**FINAL
ENVIRONMENTAL IMPACT STATEMENT**

**Continued Operation of K-, L-, and P-Reactors
Savannah River Site
Aiken, South Carolina**

APPENDIX C

RESPONSES TO PUBLIC COMMENTS ON DRAFT ENVIRONMENTAL IMPACT STATEMENT CONTINUED OPERATION OF K-, L-, AND P-REACTORS

SAVANNAH RIVER NUCLEAR SITE / CHERNOBYL COMPARISON:
A MINOR ACCIDENT - 1 REACTOR - ONLY 3% TO 4% OF CORE MELT
APPROX. 1,000 SQUARE MILE AREA OUTSIDE SITE
BOUNDARY CONTAMINATED FOREVER, AND UNINHABITABLE
AS AT CHERNOBYL. THIS AREA REQUIRES IMMEDIATE

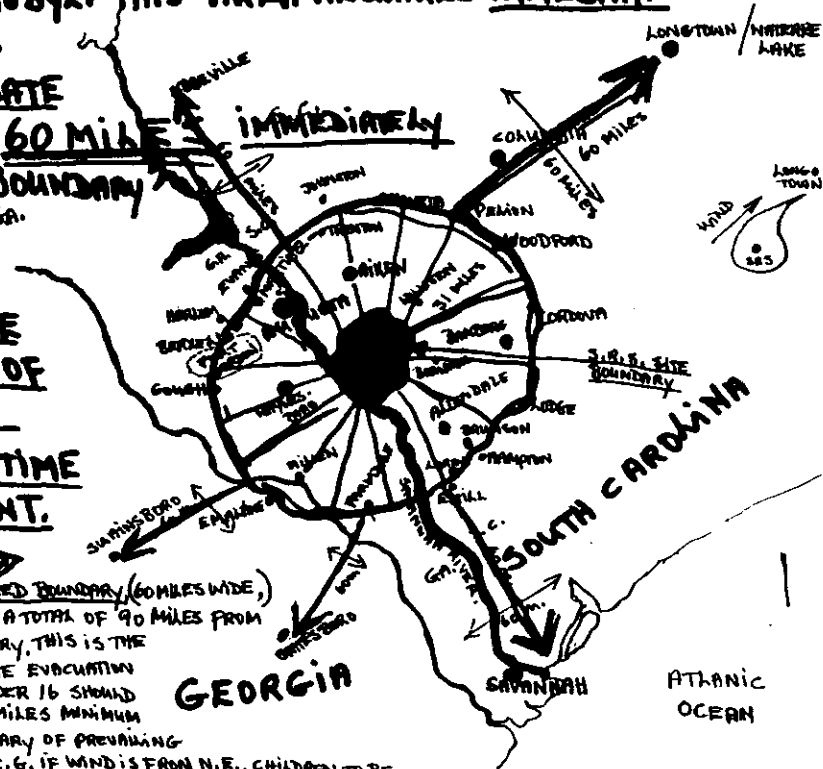
Comment Number	Comment	Response
S-05-08	<p>evacuation only goes 10 miles from the site according to what you say on p.3-61. You'd need to evacuate everyone <u>immediately</u> in a 30 mile radius of the Site boundary and a swath 60 miles wide and 60 miles long along the plume wind direction path added to that - a total of 90 miles. All pregnant women and children under 16 and the elderly to be taken an extra 10 miles to a total of 100 miles minimum. Everybody out, not to return. If the plume headed for the coast and Savannah, the poor people would have to try and outswim it - even a Dunkirk type rescue wouldn't work, the entire Savannah River and South Carolina/Georgia coastal waters, air, soil will be contaminated. If the wind direction went upcoast, you're talking Charleston, North Carolina, Virginia, if its west, you're talking middle Georgia, Alabama. You couldn't do it and you know it. Have you told the Savannah River Site workers with such an accident they'll either die quickly or slowly from radiation sickness with its bloody diarrhea, vomiting, bleeding under the skin? You say in here you'll take people to Fort Gordon Eisenhower Army Medical Center just up the road - be serious. The whole of Fort Gordon will be running for its life. Hundreds of thousands of people will be involved, there will be chaos and panic, traffic accidents tying up rural roads, terrified families trying to reach relatives, the University of South Carolina system alone would have about 26,000 terrified young people trying to get out, in Georgia there's a college in Statesboro I believe. By the time it was all over even Donald Trump couldn't finance the sized morgue you'd need. On page 2-55, it says in case of major accident Savannah River Nuclear Site has emergency operations centers in the vicinity of the site and the technical support center is on the site. This is insane. Have you told those people far enough away who may stand a chance if they evacuate quickly, never to return, that no insurance policy in the world covers nuclear accident that I know of?</p>	<p>The emergency plans for SRS reactors identify evacuation and sheltering plans that match the appropriate range of potential accidents, as described in Section 3.9 of the EIS.</p>

IN
WIND DIRECTION
ADD 60 MILES FROM RED BOUNDARY (60 MILES WIDE),
EVACUATE AT ONCE, A TOTAL OF 90 MILES FROM
S.A.S. SITE BOUNDARY. THIS IS THE
MINIMUM IMMEDIATE EVACUATION
AREA. CHILDREN UNDER 16 SHOULD
BE EVACUATED 100 MILES MINIMUM
FROM S.A.S. BOUNDARY OF PREVAILING
WIND DIRECTION. E.G. IF WIND IS FROM N.E., CHILDREN TO BE
EVACUATED 100 MILES OUT FROM S.W. SITE
BOUNDARY IN AN AREA 60 MILES WIDE. ADULTS 90 MILES FROM S.A.S. SITE BOUNDARY.
PREGNANT WOMEN TO BE INCLUDED IN CHILD EVACUATION DISTANCE.

Figure 4-8. Frequency of Latent (Cancer) Fatalities Due to Severe Accidents.

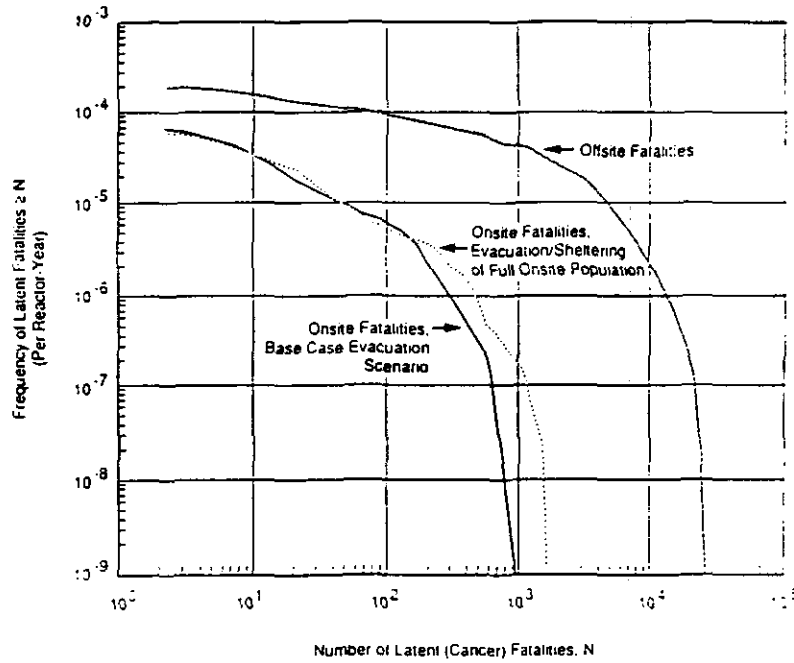
C-04-15	<p>The type of presentation used in Exhibit 2 merges probabilities of a wide variety of types and does not show the many uncertainties involved; it is, therefore, misleading.</p>	<p>Combining probabilities of independent events of different types is a valid methodology; the individual event probabilities for all release categories are too voluminous to include in the EIS, but they are in the Safety Information Document (MSRC, 1990), referenced in this EIS. Also, please see the response to Comment C-04-13 on uncertainty.</p>
C-04-16	<p>The draft EIS does not show an uncertainty range for its estimates of risk; Exhibit 4 illustrates this lack by showing the uncertainty range (itself questionable) in one estimate of core damage probability for the Peach Bottom commercial reactors.</p>	<p>DOE has rewritten Section 2.1.3.1.2 of the EIS to include the Level-1 PRA core-damage frequencies. DOE also has changed Section 4.1.3.1.5 to include a discussion on uncertainty.</p>

**Potential Area Where Thyroid Inhalation Dose
Would Exceed 100 rem Following a
Severe Accident at an SRP Reactor**

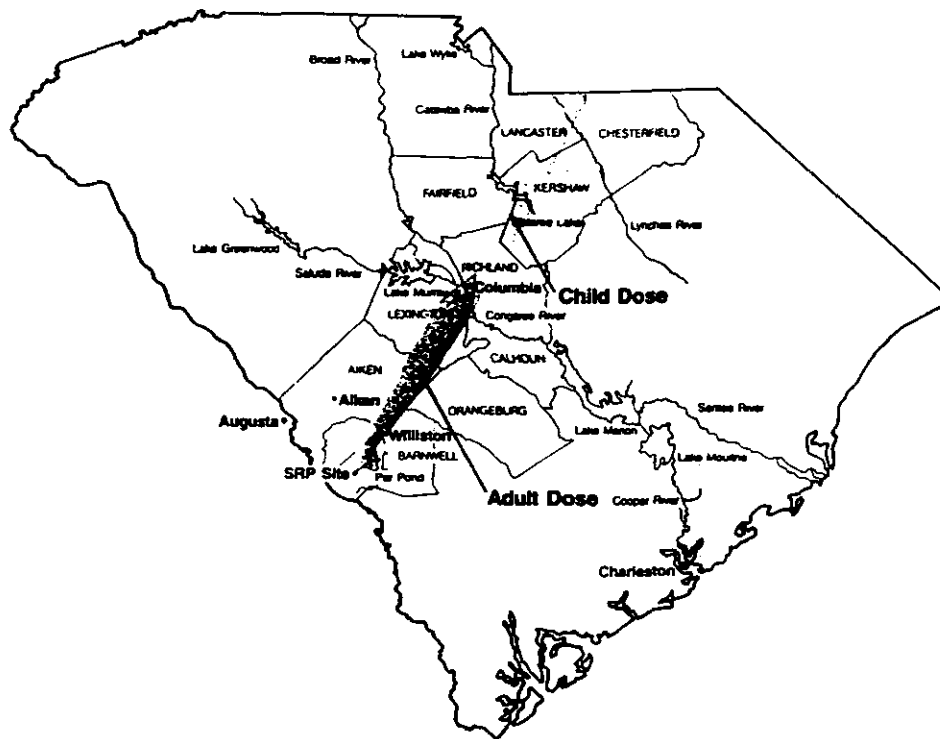
C-04-18	<p>The draft EIS should, but does not, show the geographic extent of potential human injury or environmental degradation resulting from a release of radioactivity; that extent is illustrated by computer-derived estimates shown in Exhibits 7 and 8 (a map of ground contamination from the Chernobyl accident is shown in Exhibit 9, for comparison).</p>	<p>Section 4.1.3.1.4 of the EIS presents the extent of potential human injury from radioactivity released from design-basis accidents in terms of median doses to hypothetical individuals at the SRS boundary, consistent with the approach to environmental analyses of accidents at commercial reactors. Section 4.1.3.1.5 presents the consequences for severe accidents in terms of the risk of prompt and delayed fatalities to individuals and to the population within 500 miles of the SRS.</p>
C-04-19	<p>Exhibits 7 and 8 were based on a hypothetical release of 50% of iodine and cesium isotopes; Exhibit 10 shows that this assumption was reasonable.</p>	<p>As presented in the Safety Information Document (WSRC, 1990), which is referenced in the EIS, the eight release categories referred to in Exhibit 10 have a combined probability of less than 1×10^{-5}, or less than 5 percent of the total core damage probability. The corresponding releases have been included in the accident consequences reported in the EIS, weighted in accordance with their respective probabilities of occurrence.</p>
